## DEVELOPMENT APPLICATION ASSESSMENT REPORT

<b>Application Number:</b>	DA2022/2207
----------------------------	-------------

<b>Responsible Officer:</b>	Jordan Davies
<b>Land to be developed (Address):</b>	Lot A DP 358783, 30 Abernethy Street SEAFORTH NSW 2092
<b>Proposed Development:</b>	Demolition works and construction of a dwelling house including swimming pool
<b>Zoning:</b>	Manly LEP2013 - Land zoned R2 Low Density Residential
<b>Development Permissible:</b>	Yes
<b>Existing Use Rights:</b>	No
<b>Consent Authority:</b>	Northern Beaches Council
<b>Delegation Level:</b>	DDP
<b>Land and Environment Court Action:</b>	No
<b>Owner:</b>	Adam Scott Mcdougall Jasmin Alicia Bobyk
<b>Applicant:</b>	Luxitecture Pty Ltd

This development application seeks consent for demolition of an existing dwelling and construction of a new dwelling house and swimming pool.

Figure 1 - Extract from plans showing 8.5m height blanket.

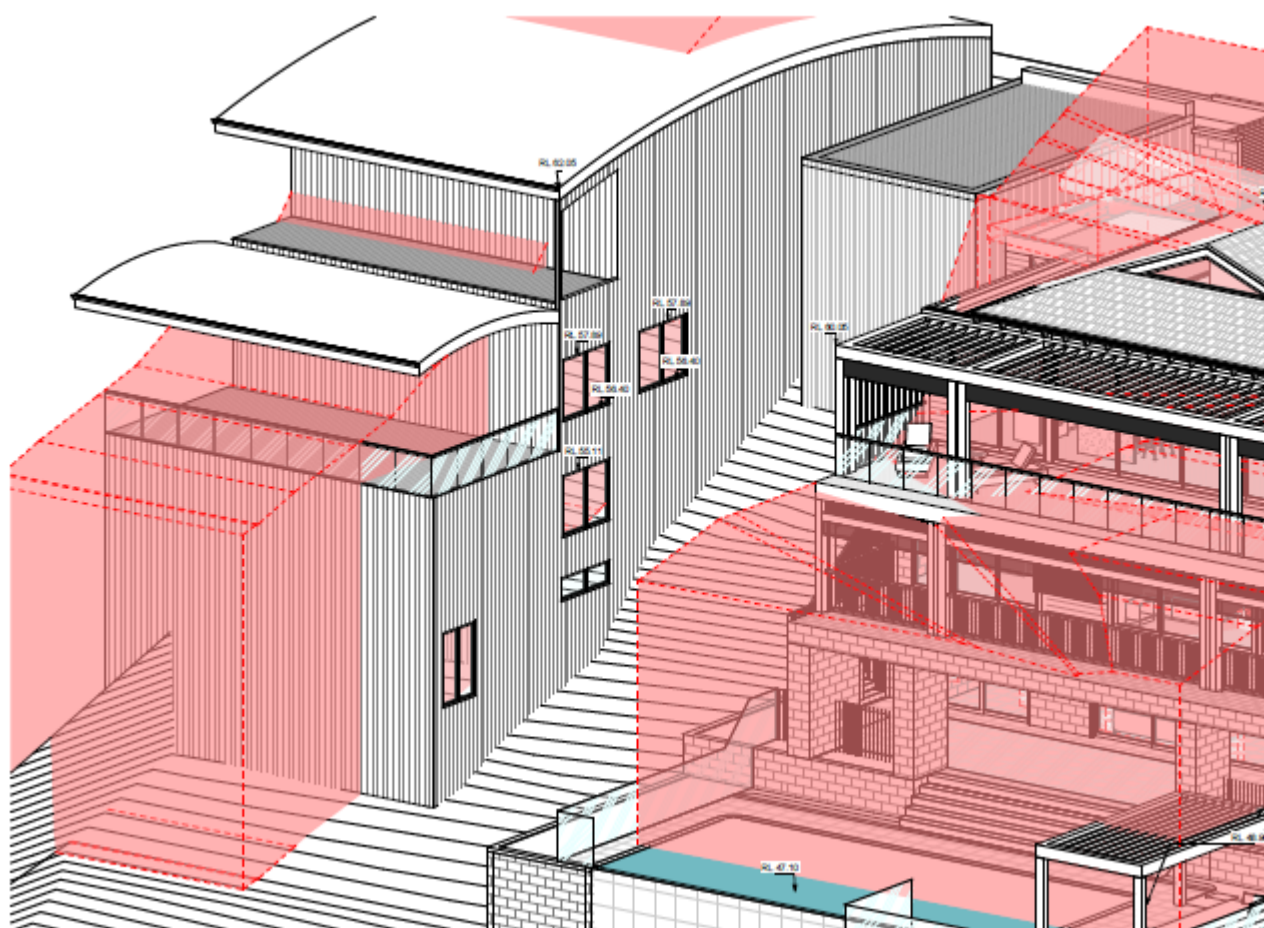
Development standard:	Height of buildings
Requirement:	8.5m
Proposed:	6.2m to 11m
Percentage variation to requirement:	29.4%

Figure 2 - Extract from plans showing a section plan and 8.5m height plane. Yellow areas represent areas of encroachment.

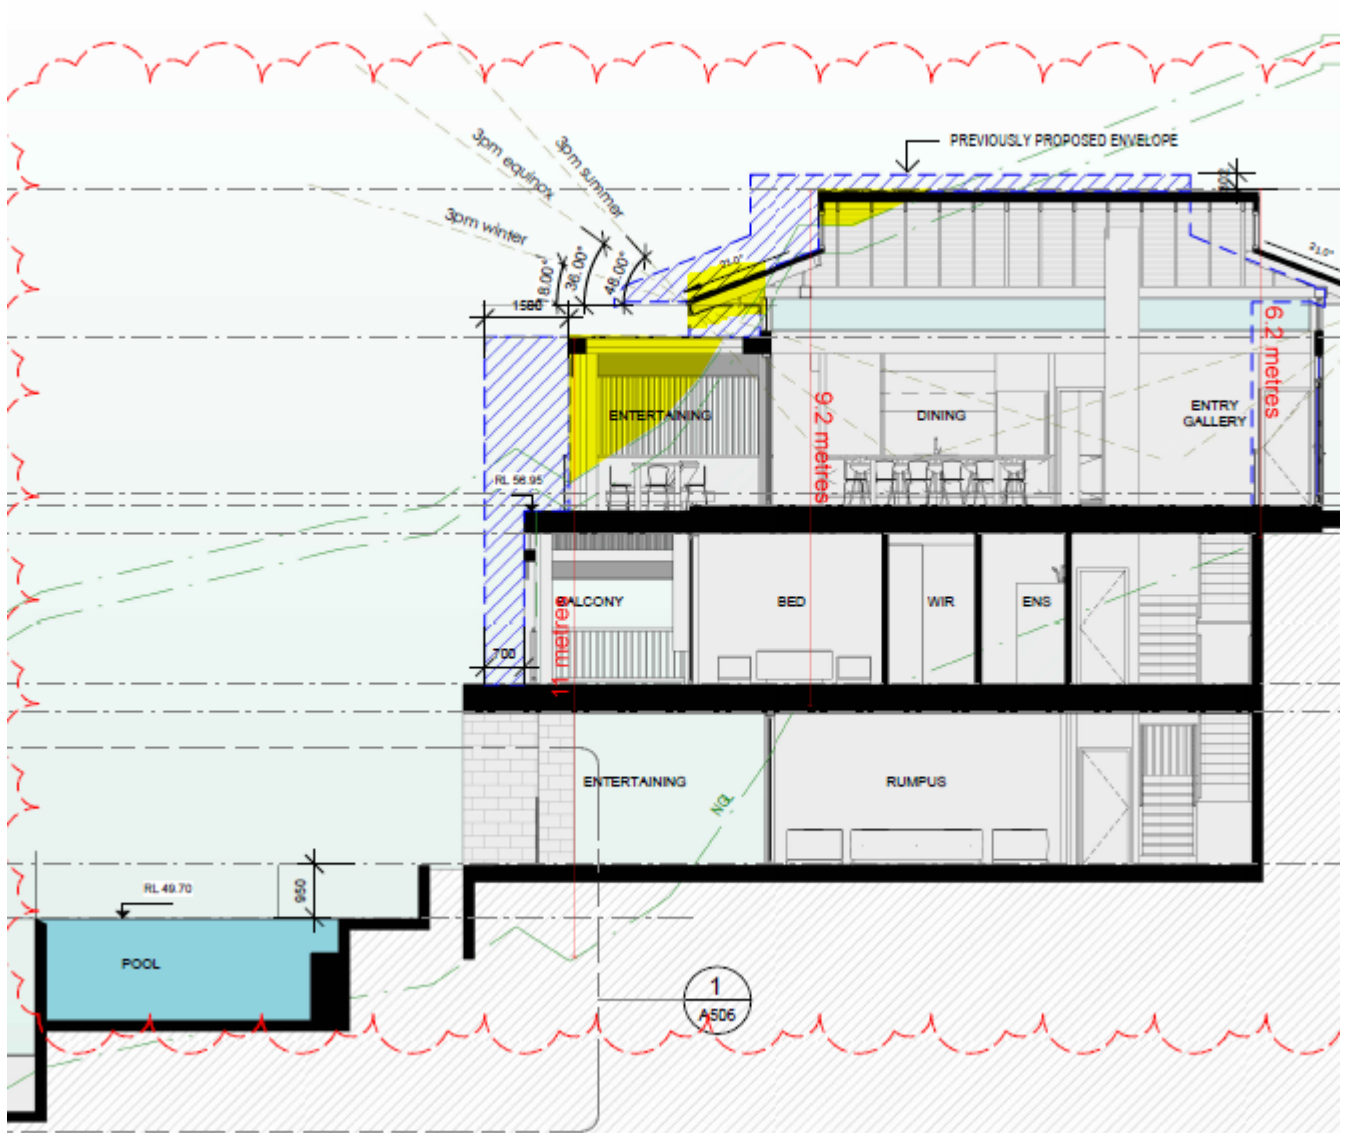
The environmental planning grounds as set out within the Clause 4.6 request are agreed with. In particular, the steepness of the site and the series of rock boulders toward the center of the site creates a steep drop off that makes compliance difficult to achieve, particularly when there is a balance to be achieved with the siting of the dwelling with regards to view sharing and achievement of high quality solar access having regard to the position of the dwellings on the adjoining sites.

**Figure 3 - Extract taken from Clause 4.6**

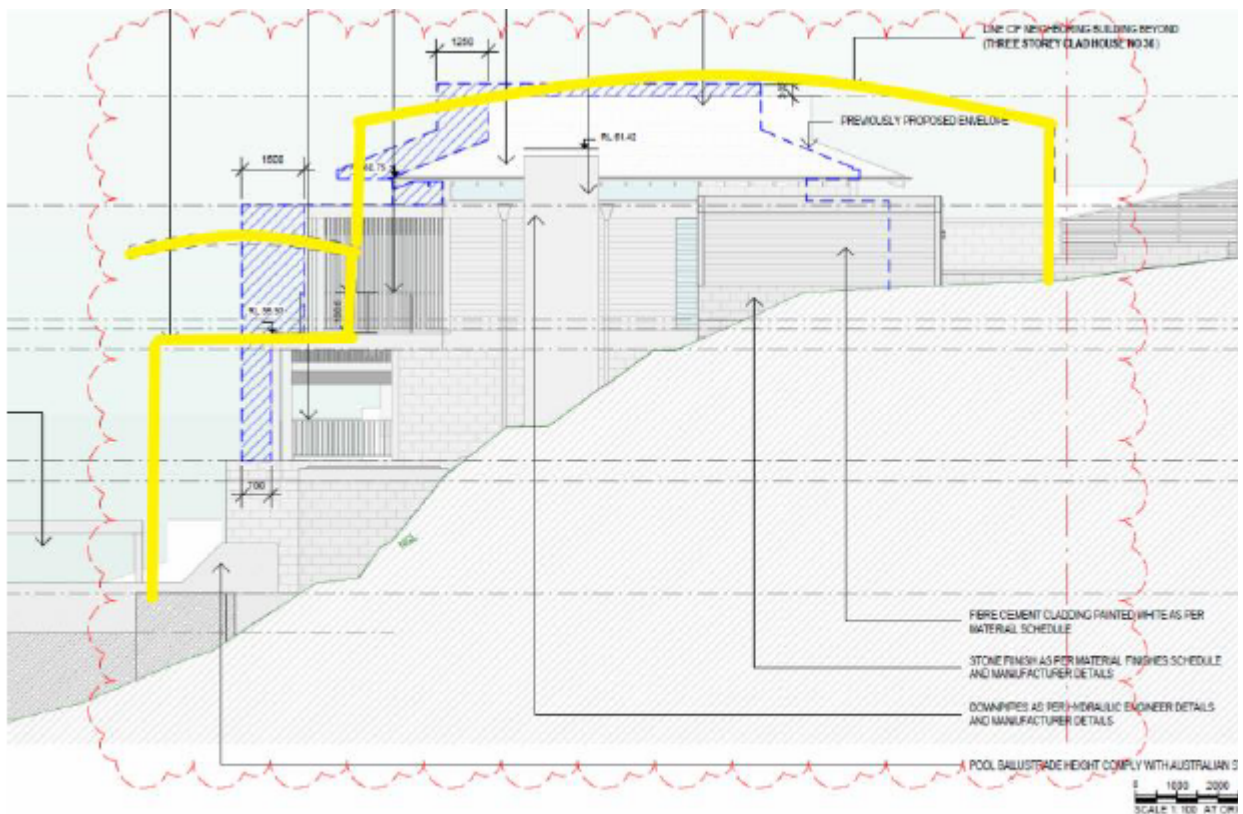
- *The proposed dwelling is consistent with the scale and number of storeys with regard to development within the immediate vicinity. Dwellings in the area are multistorey which reflects the steep topography. Drawing A201, southern elevation, provides an outline of the adjoining dwelling at No. 36. The outline is highlighted in yellow and demonstrates the reasonable scale in terms of height of the proposal.*

**Figure 4 - Extract taken from applicant's Clause 4.6**

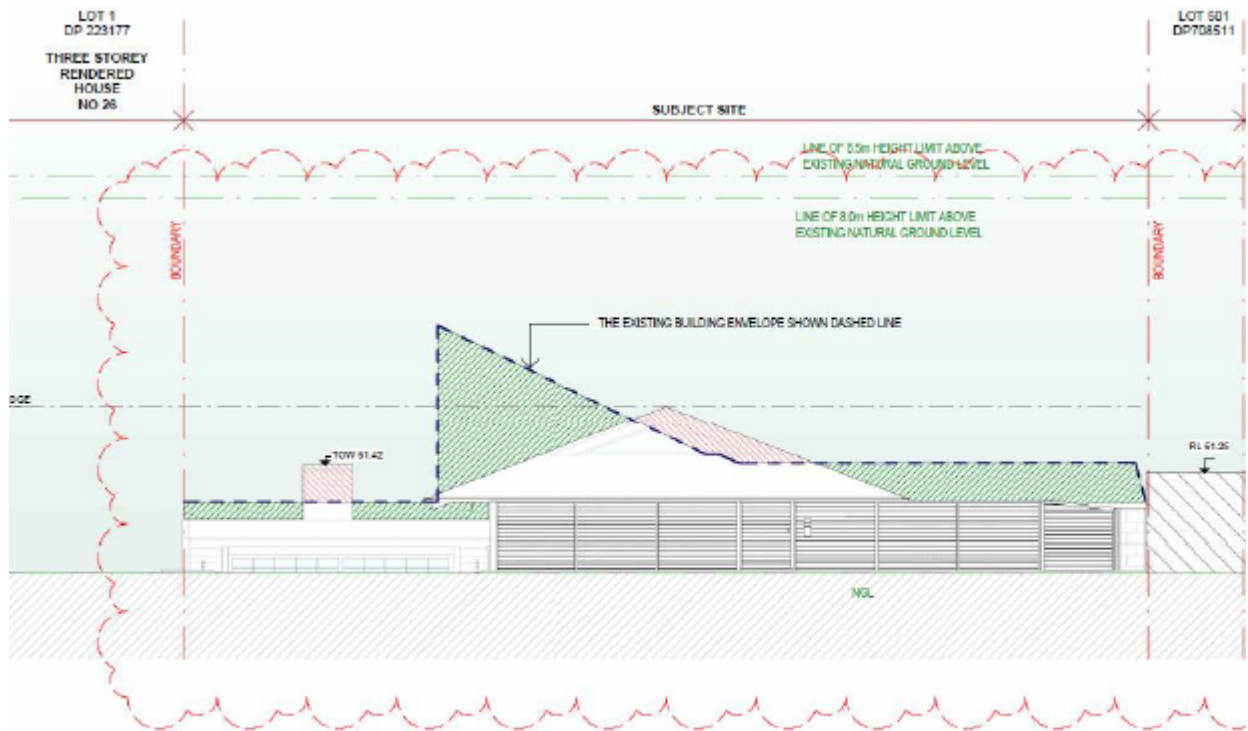
- *The ability of the dwelling to step down the slope is negated by the steepness however amendments have been made to push the first floor back towards the front boundary. The dwelling will better reflect the topography of the site in that regard which generally encourages development to step down sloping sites.*
- *The proposal will reduce the height of the dwelling as it relates to the streetscape and will contribute positively to its character above that of the existing dwelling. Streetscape analysis is provided below which shows the existing unusual built form to be demolished to be replaced with a more traditional cohesive design. The height of the dwelling as it presents to the streetscape will be reduced.*

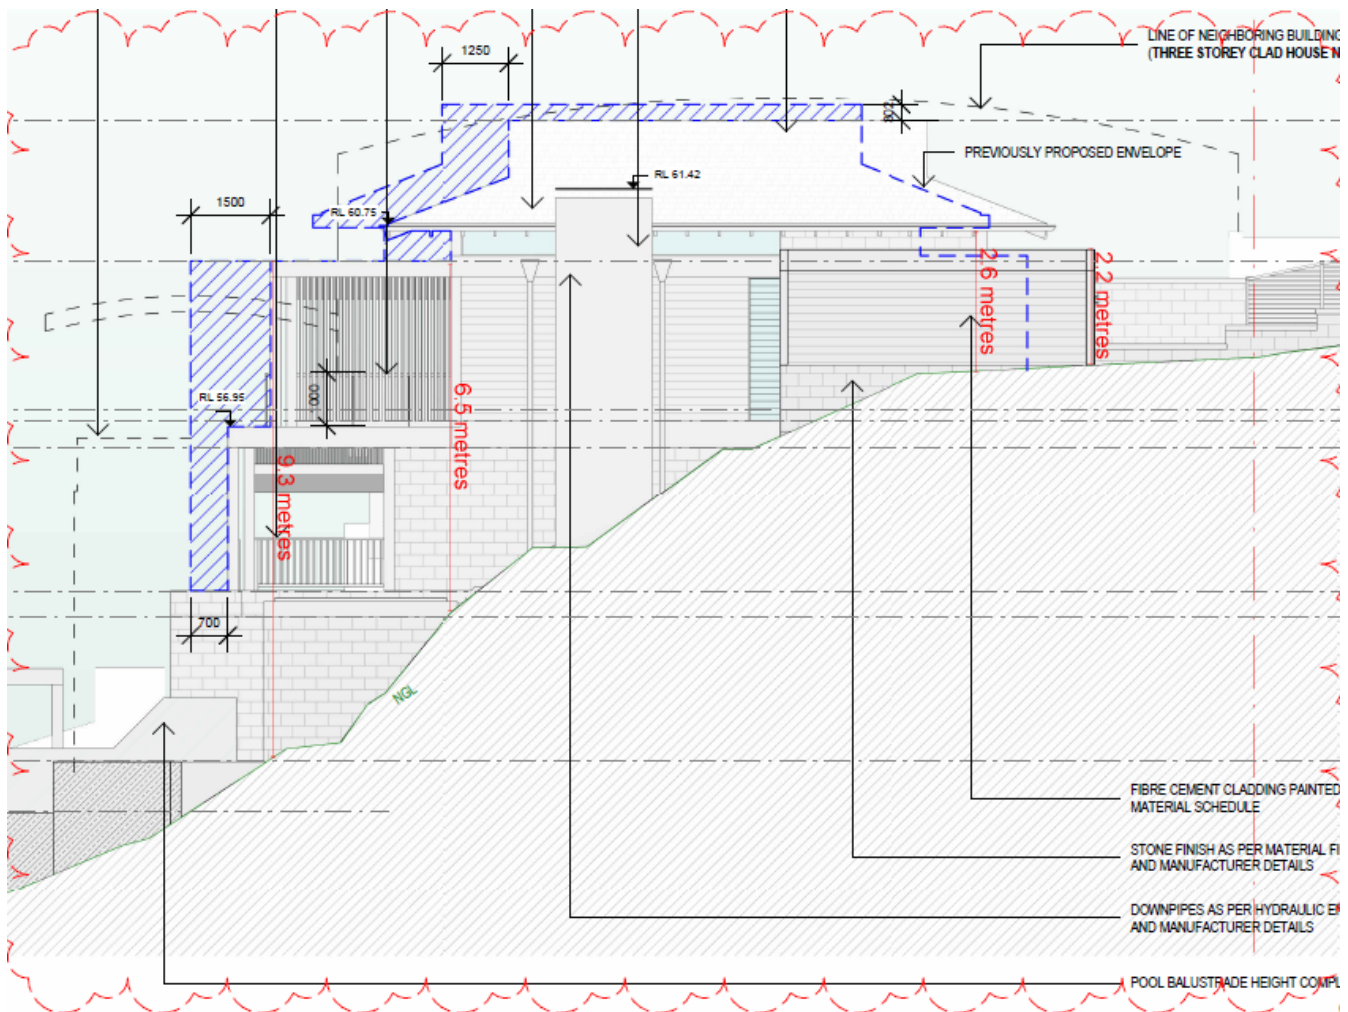
The DCP requires a maximum wall height of 8m when the site slope of 1:4+ gradient. The site, in

particular in the area of non-compliance, has a slope of 1:2 and in some locations, a near vertical drop due to a rock outcrop.

The northern wall is between 3.1m and 9.5m, with the pergola up to 10.8m, see below:

**Figure 2 – Southern elevation showing the revised plans with increased setback to the western boundary and reduced ridge height of the roof form.**

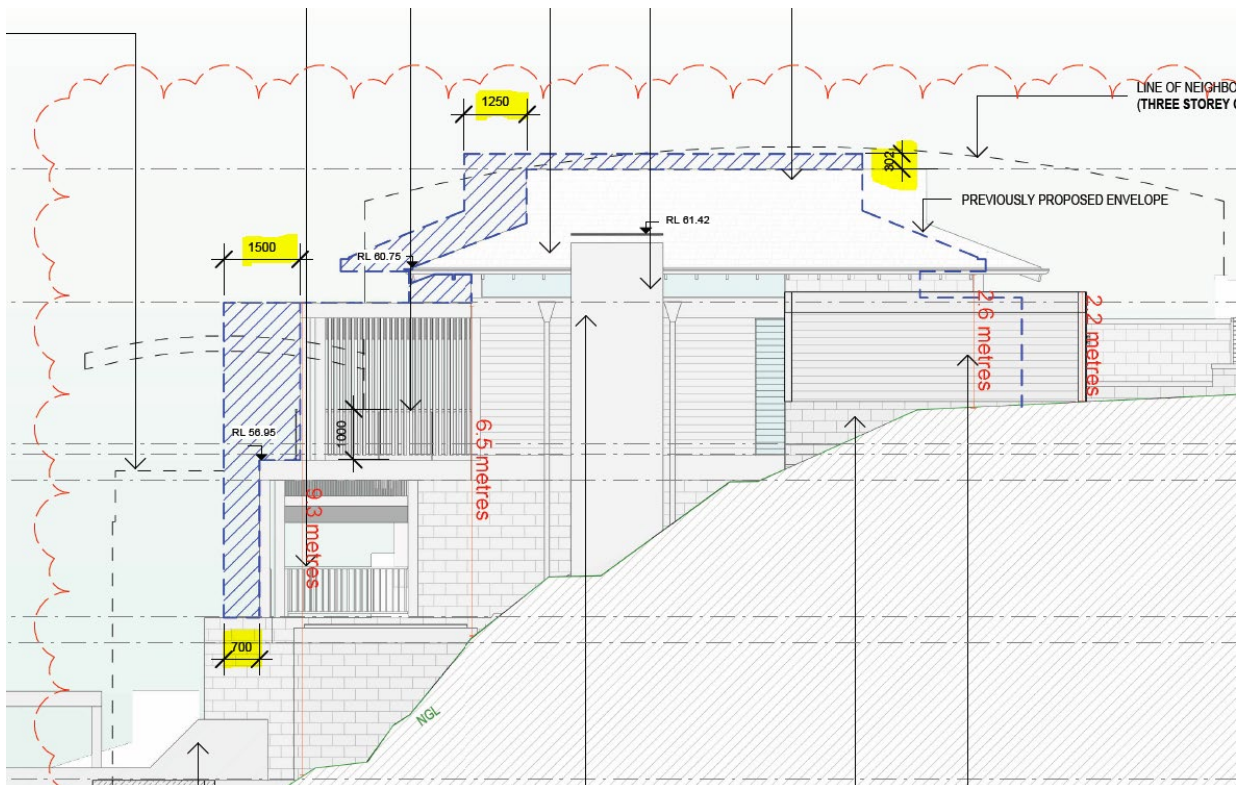
It is important to note that the location of the height poles **represent the original plans as submitted**. The amended plans reduce the height of the central roof pitch by 302mm and move the roof 1.25m closer to the front (eastern) boundary. The upper-level pergola is also setback 1.5m and the lower-level pergola setback 0.7m.
